Transit, Bicycle, and Pedestrian Improvement Study

Williston and Shelburne Roads South Burlington, Vermont

September 1, 1993

PLANS ADDENDUM TO THE DISABILITY COUNCIL'S REPORT,
'CHANGES TO THE PHYSICAL ACCESSIBILITY COMPONENTS OF THE
TRANSIT, BICYCLE, AND PEDESTRIAN IMPROVEMENT STUDY
FOR WILLISTON AND SHELBURNE ROADS'

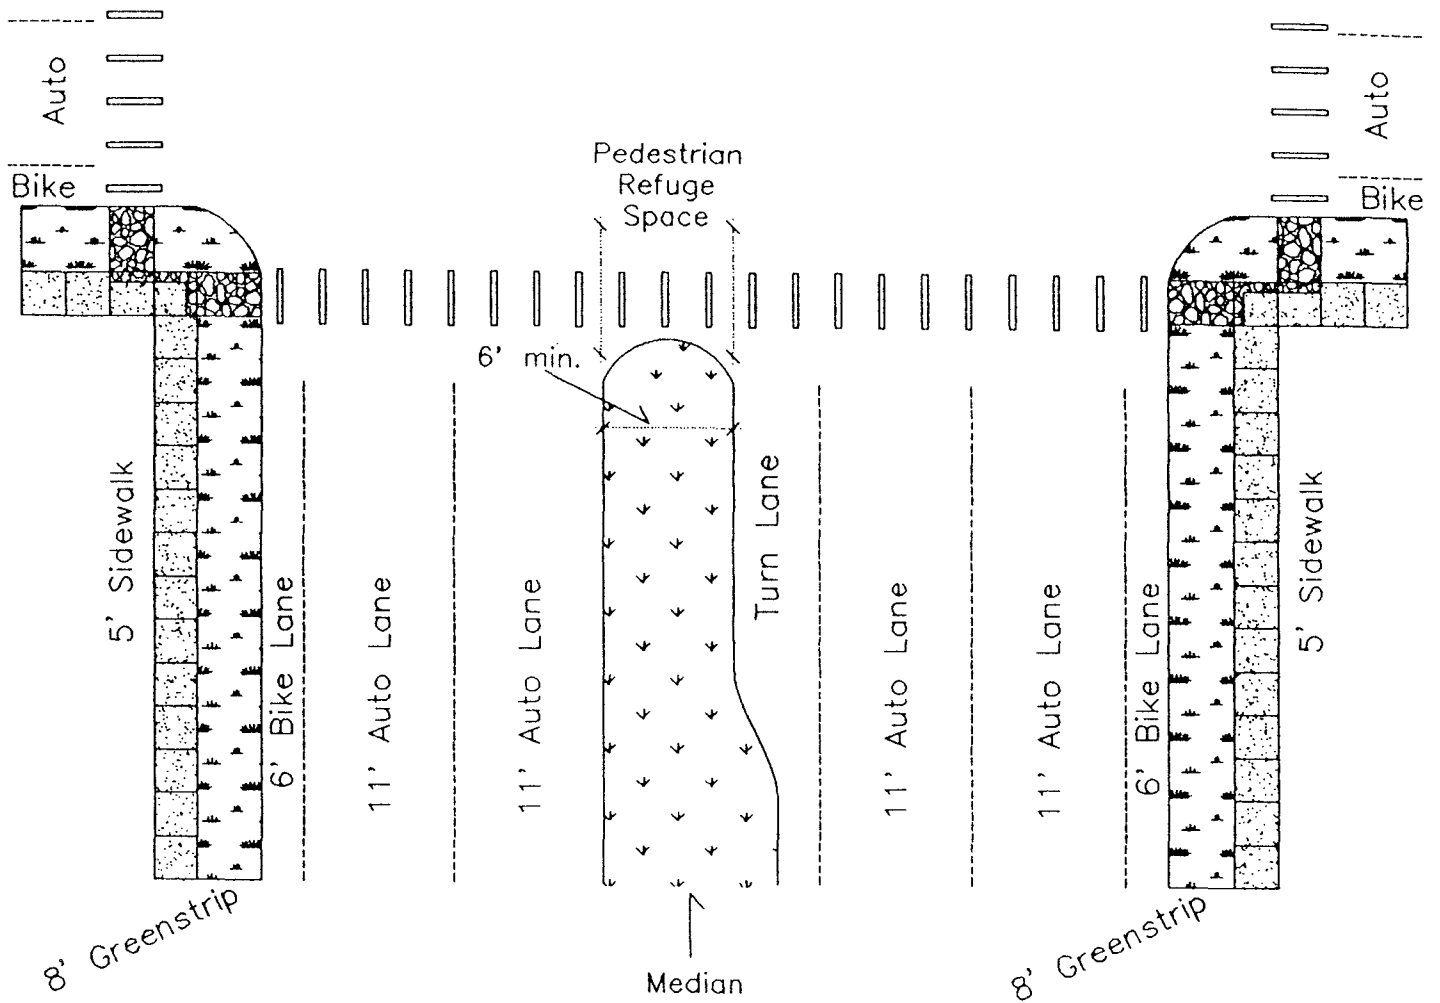
This is not to say that traffic control or pedestrian refuge constructs cannot be designed in such a way that they both serve the desired purpose and insure accessibility. One such design, "Pedestrian Refuge Space", which is a modification to the "Plan □ Typical Intersection □ Imperial Drive to I-189 Bridge" design shown on the "Recommendations" Plan, Sheet 1 of 2, is attached to this narrative.

NOTE: This drawing illustrates an accessible alternative to pedestrian refuge islands only. It is not intended to show all of the details necessary for accessible pedestrian spaces at an intersection, i.e., it does not show pedestrian activated signals, bus stops and shelters, drain grates, etc.
